IN THE SPECIFICATION

REMARKS

Claims 86-107, 109-123, 125 and 126 are pending in this application.

FIG. 11

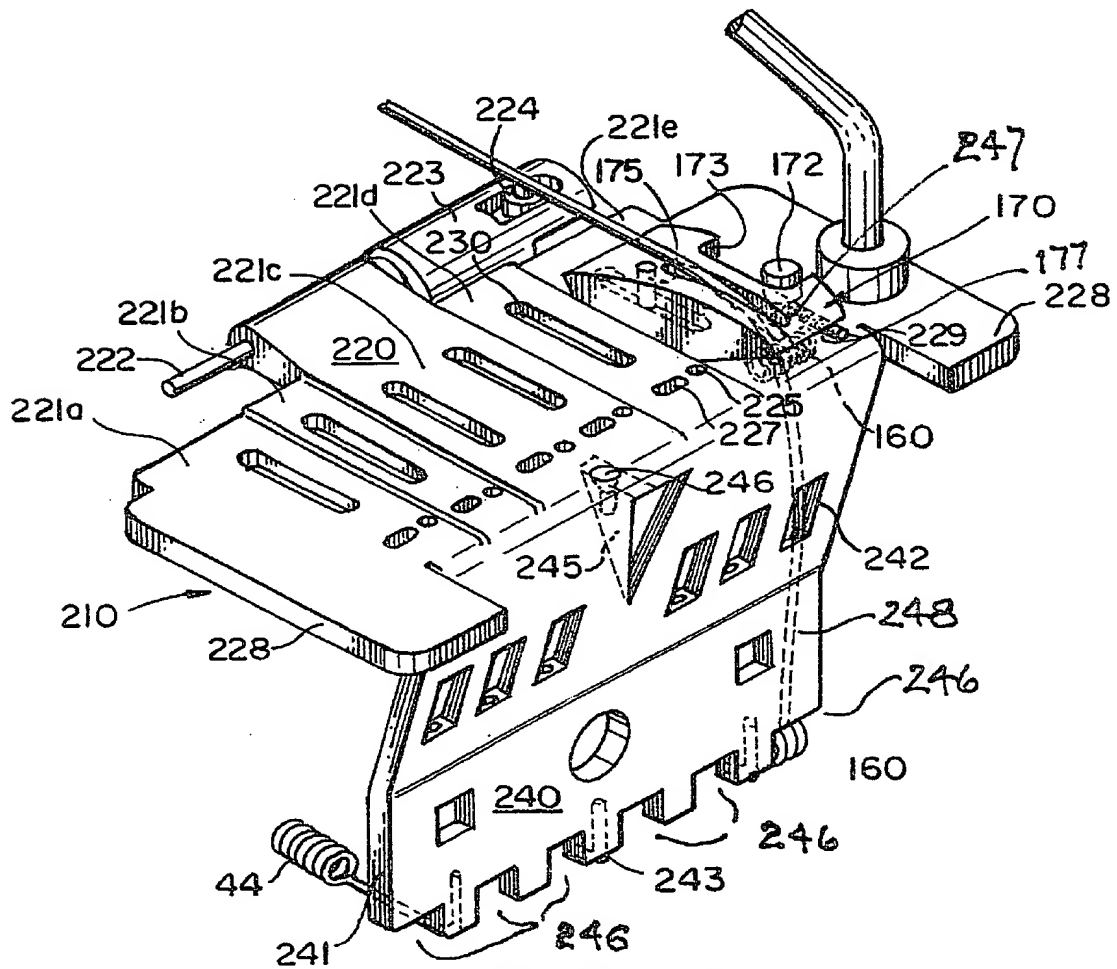
The drawings are objected to under CFR 1.83(a);

Figure 11. is amended to include:

- number 177, the rearward portion of intonation module 170, previously presented in phantom only;
- number 246 to denote string anchoring points on the lower portion 140 of spring block or spring blade 240 for receiving anchoring ball 160;
- number 247 to indicate the alternate string anchoring point for receiving anchoring ball 160 on the rearward portion 177 of 170;
- number 248 to indicate the “elongated cylindrical passageway” in the string blade or spring block.

The rearward surface 177 of the intonation module 170 ~~provides~~ includes the alternate string anchoring point 247 as shown in Fig. 11, the string can be anchored to the end of the intonation module so that string anchor 160 bears against the rearward outer portion 177 of the intonation module 170. This alternate anchoring position of string anchor 160 is illustrated in phantom in Fig. 11. A hole or slot 247 is narrower than the width of the string anchor 160, but wider than the diameter of the string. The string extends though the hole or slot 247 and string anchor 160 bears against the rearward surface 177 to anchor the string.
